# **Service Letter**

SL: 40027

**Subject:** Speed Sensor Connector

MODEL	SERIAL NUMBER
7/51	443500 & Above
7/71-12/56	522700 & Above

Figure 2

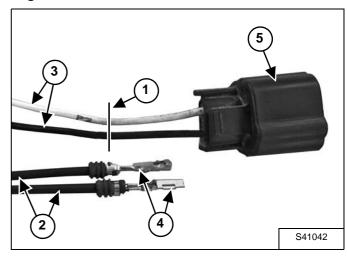
Cut the wires 20 mm (0.79 in) (Item 1) from the original connector and attach the pre-crimped leads (P/N 46551241) (Item 2) to the original white and black wires (Item 3) [Figure 2] using crimp on the connections.

Insert the terminals (Item 4) in the new or original connector (Item 5) **[Figure 2]**.

Figure 3

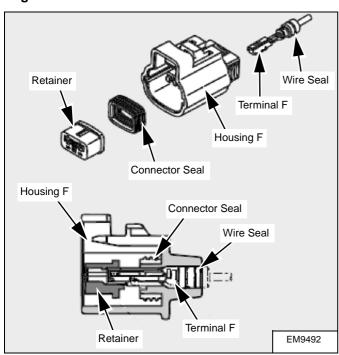
For the correct installation, see [Figure 3].

Figure 5

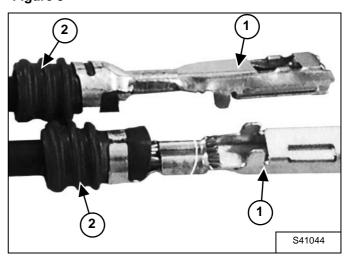
When crimping your own terminals (Item 1) as when option 1 is used, ensure that the terminal crimped also envelopes the black wire seal (Item 2) [Figure 5] as shown.
